# RENESAS TECHNICAL UPDATE

Product Category	MPU/MCU		Document No.	TN-H8*-A433A/E	Rev.	1.00
Title	H8S Family / H8S/Tiny Series Notice of change of a list of products		Information Category	Technical Notification		
Applicable Product	H8S/20103R, H8S/20203R, H8S/20223R, H8S/20323R, H8S/20115R, H8S/20215R, H8S/20235R, H8S/20335R Groups	Lot No.  All lots	Reference Document	H8S/20103R, H8S/20203R, H8S/20223R, H8S/20323R, H8S/20115R, H8S/20215R, H8S/20235R, H8S/20335R Groups User's Manual: Hardware (R01UH0185EJ0300 Rev. 3.00)

Figure 1.1 How to Read the Part Number

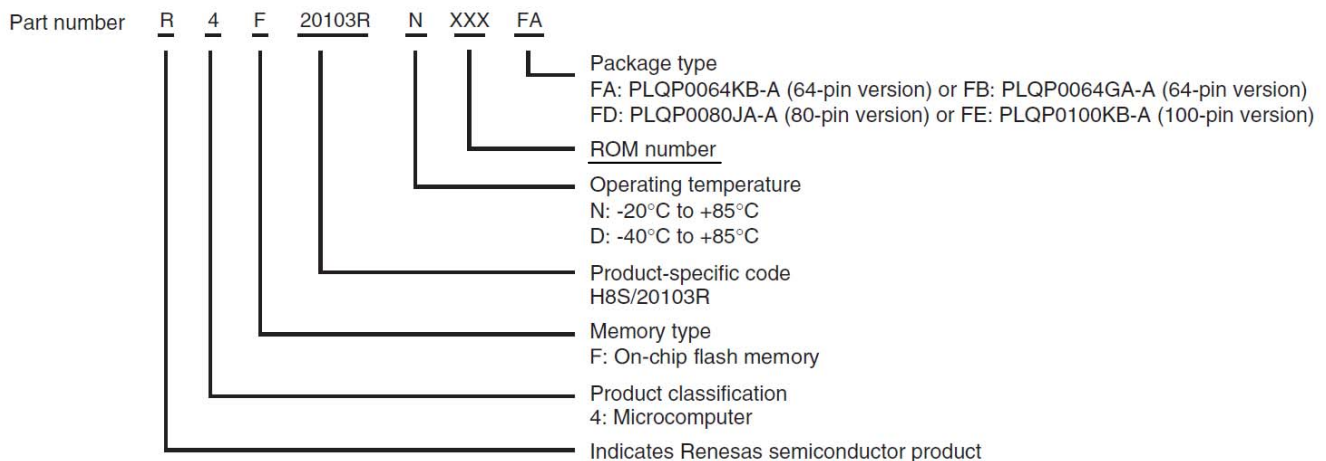
We would like to inform you of the descriptions to be deleted from List of Products, and of an amendment of how to read the part number.

[Before amendment]

Figure 1.1 How to Read the Part Number

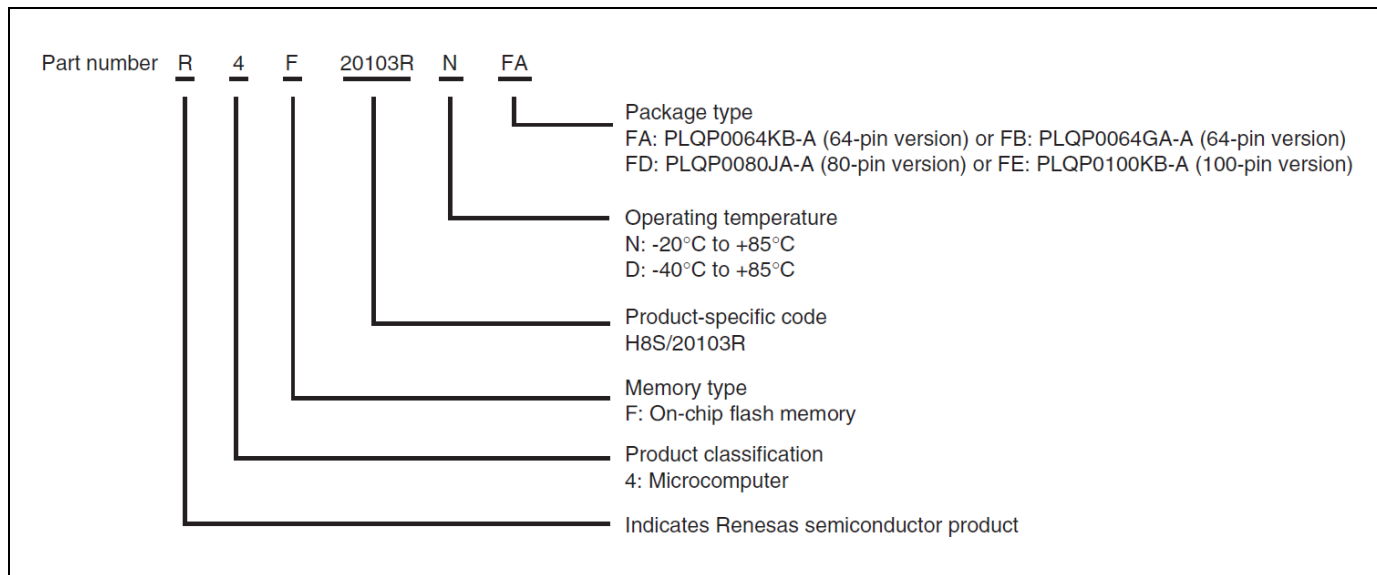
[After amendment]
